Sawyer County

Land, Water, & Forest Resources Committee Meeting
Wednesday, December 8, 2021 @ 8:30 AM
Assembly Room

SUBJECT: Upper Brunet 2021 Reconstruction Plan Review Comments Dated February 23, 2021

Reference: Upper Brunet Dam, Repair and Modification, FF 57.32, Sequence No. 198
Morgan & Parmley No. 2020-109

BRUNET DAM REPAIRS ROLLER ASSEMBLY	
TOWN OF DRAPER SAWYER COUNTY, WISCONSIN	
SCALE - 6"=1'	MORGAN & PARMLEY, LTD. CONSULTING ENGINEERS LADYSMITH, WISCONSIN DR. BY E.G.
SHEET 7 OF 12	
DATE 11-22-2021

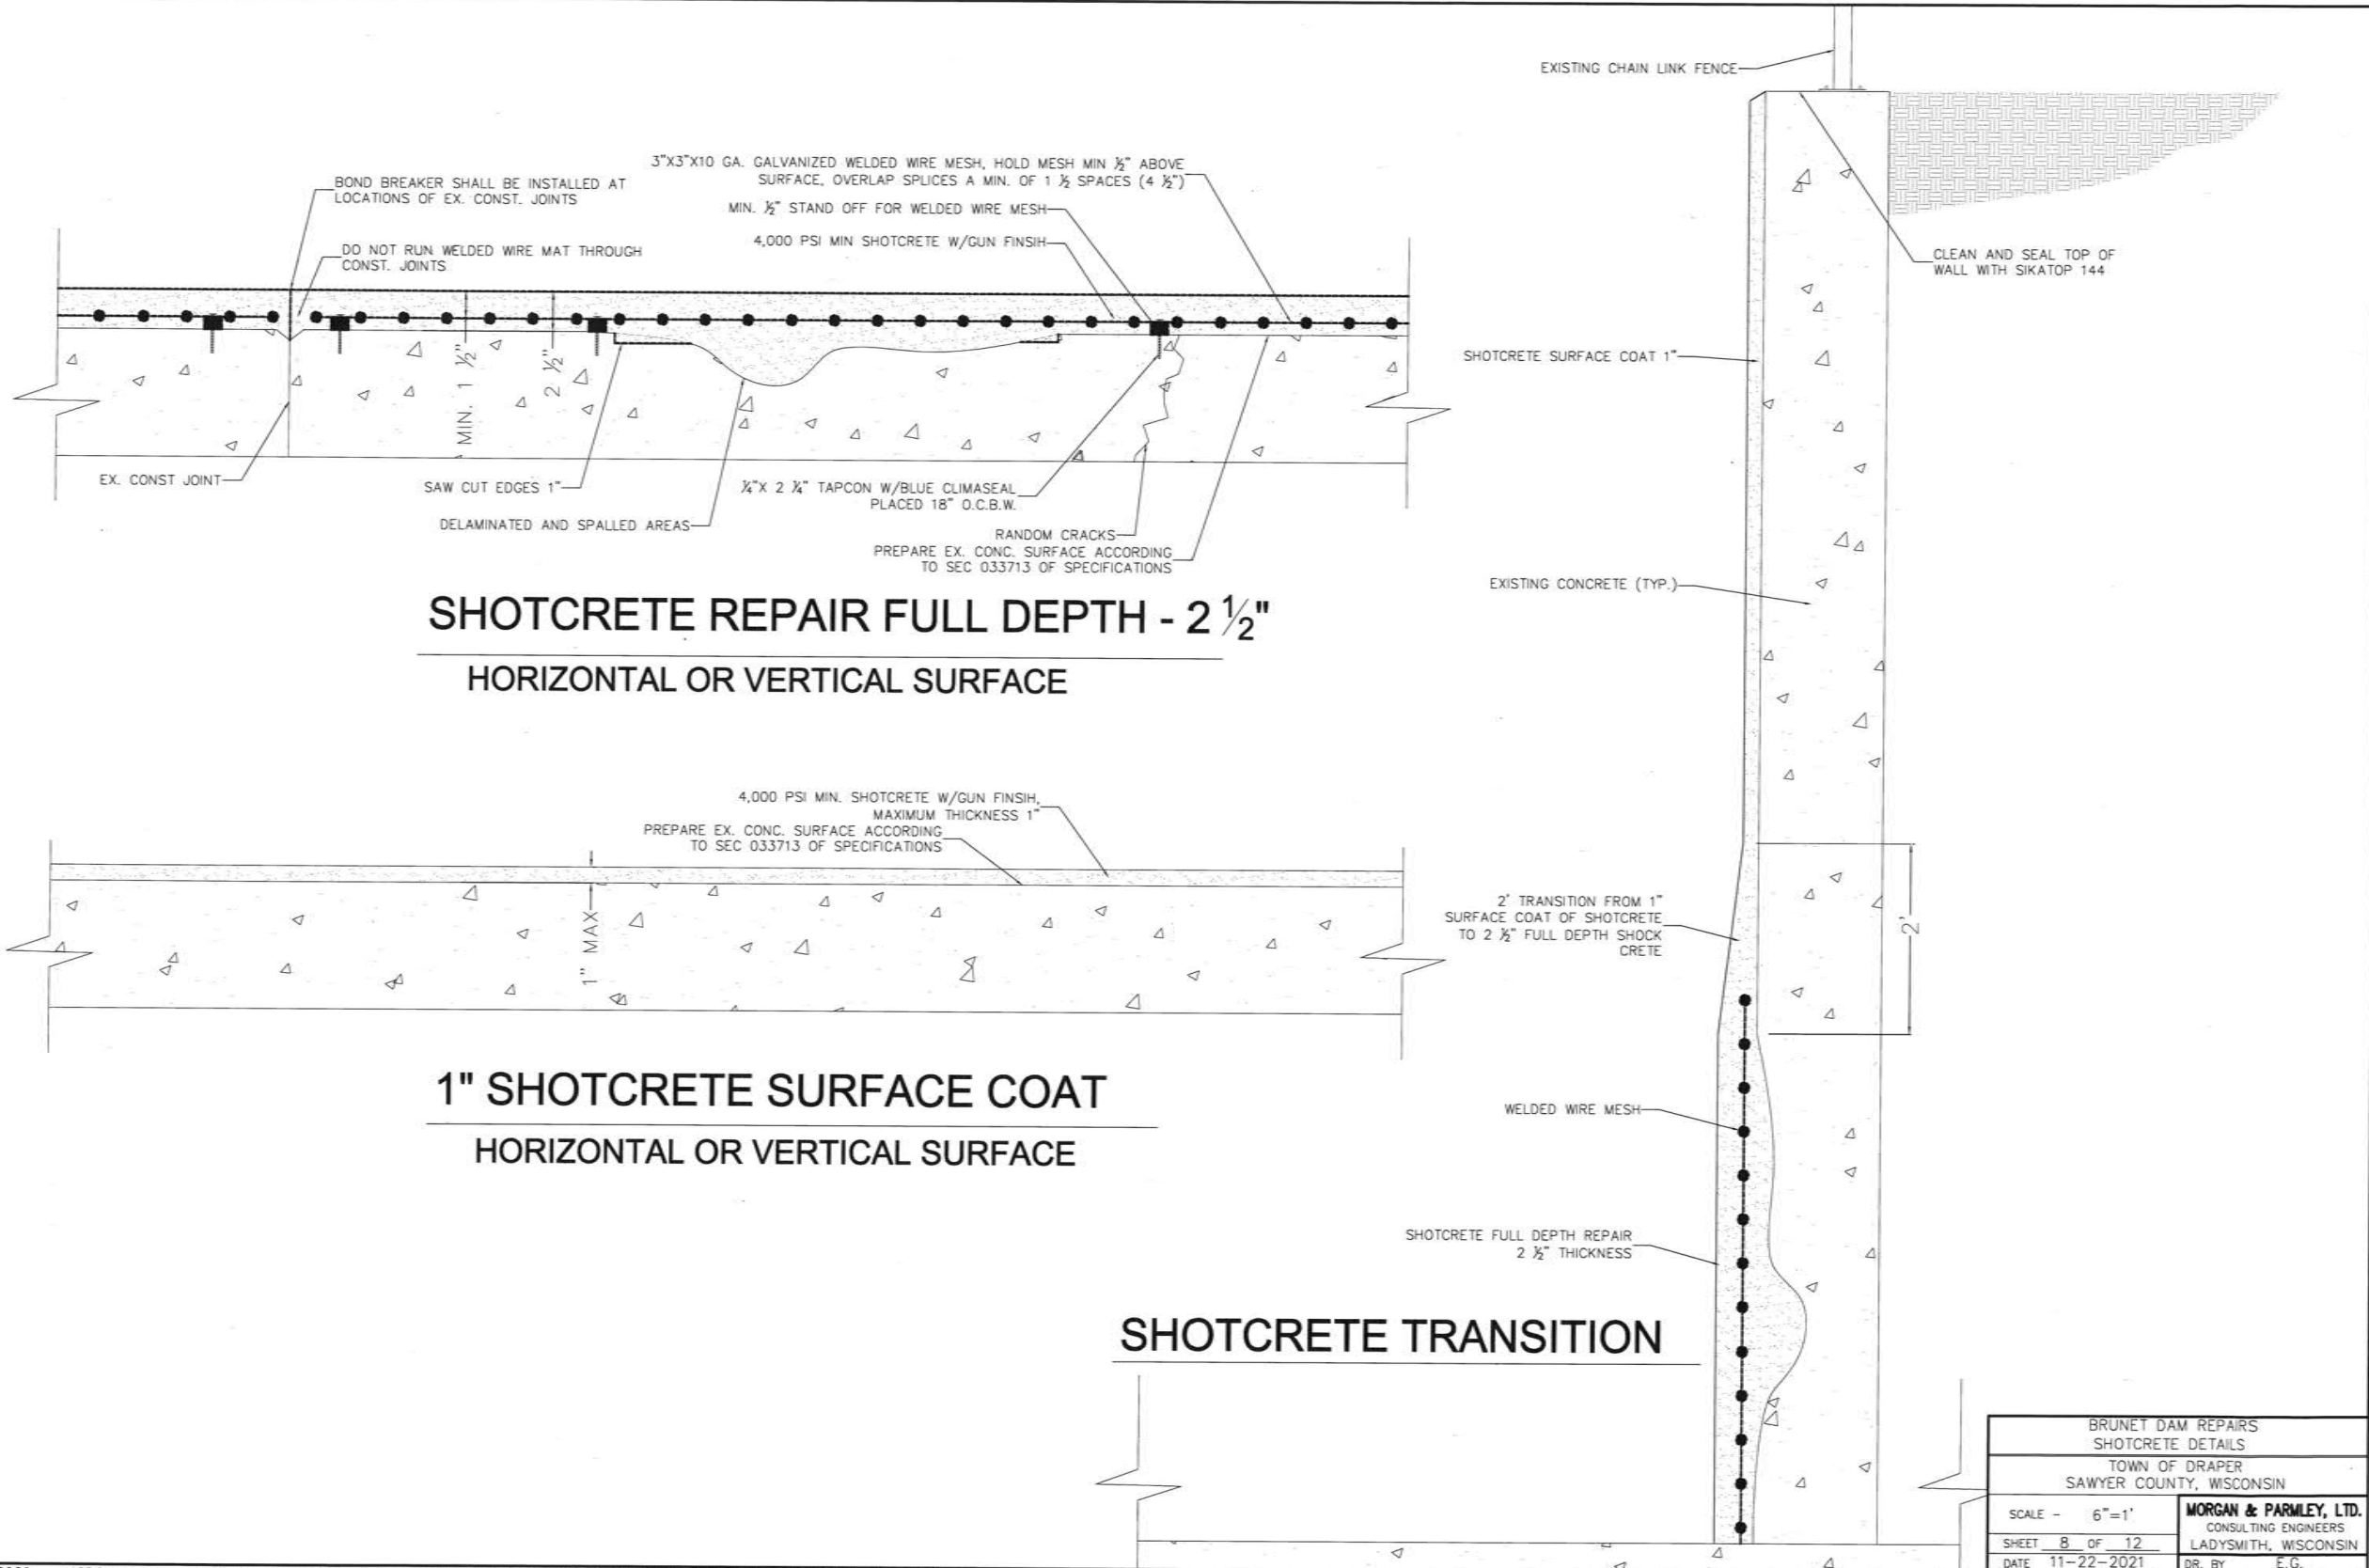
- c. Please provide a detail for downstream cofferdam/sandbag design. Include height and width of bags. How much freeboard will be provided for possible storm events during construction? Will the bags be stable under higher adjacent velocities when all discharge moving through Bay 3 (Phase 1)?

- c. Our typical sandbag detail is included on plan sheet 7. The second bullet on the Plan of Construction notes that the apron elevation is 1378 and normal tailwater elevation is less than 1380; normal tailwater depth is less than 2' deep. The top of the sand bags would be 3' high, provide 1' of freeboard for a 2' tailwater elevation. The downstream sand bags are being installed to accommodate construction only. The contractor will dewater the area behind the sand bags as needed for construction. The sand bags will be placed on a concrete apron. Overtopping the sand bags only effects construction and not the downstream public.

BARRICADES AND SIGNS FOR SIDEROAD CLOSURES

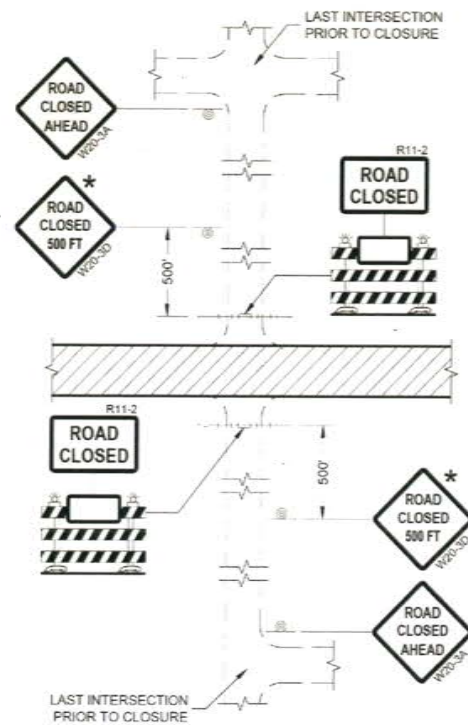
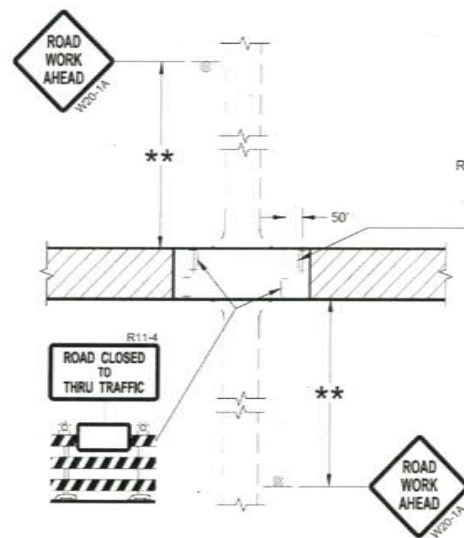
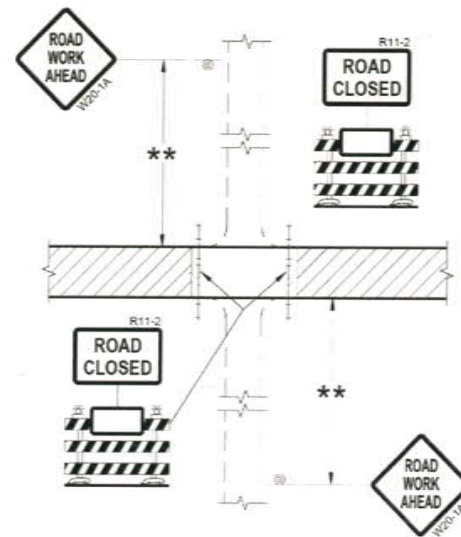
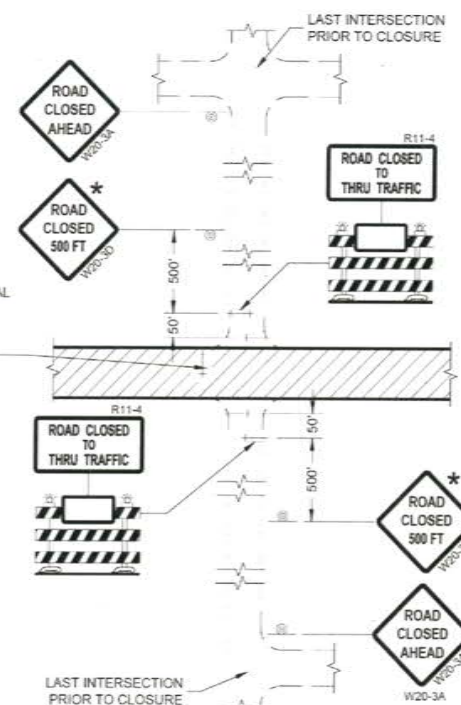
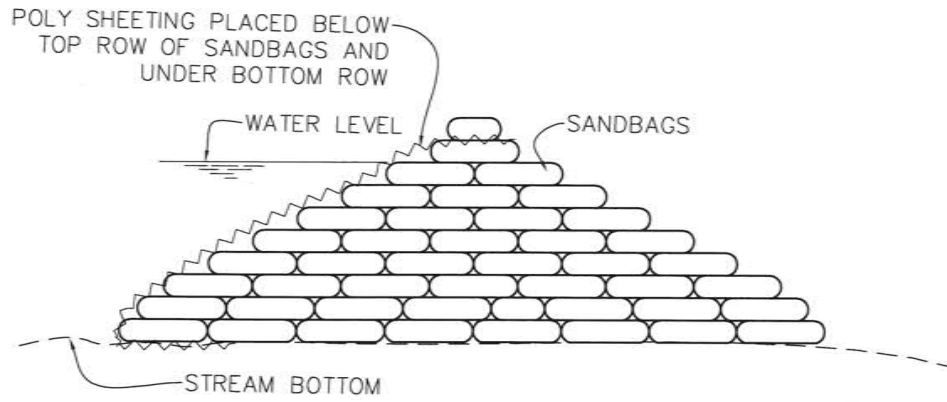
- e. Provide a sign detail for traffic control/road closures.
 - f. The plans do not demonstrate a new lift device for the new Bay 3 slide gate. Is this accurate?

- e. A sign detail, WI DOT SDD 15C03-05 has been added as plan sheet 11, Section 01010 revised, and a bid item added for traffic control.
- f. Bay 3 will reuse the existing polymer stop logs (they will be removed, cleaned and reinstalled) which will only be used as a lake drain. The County has a service truck with a boom that can be used to remove the stop logs when the need arises. The need is only anticipated to occur when repairs are made on the upstream face of the dam; estimated once every 20 years.
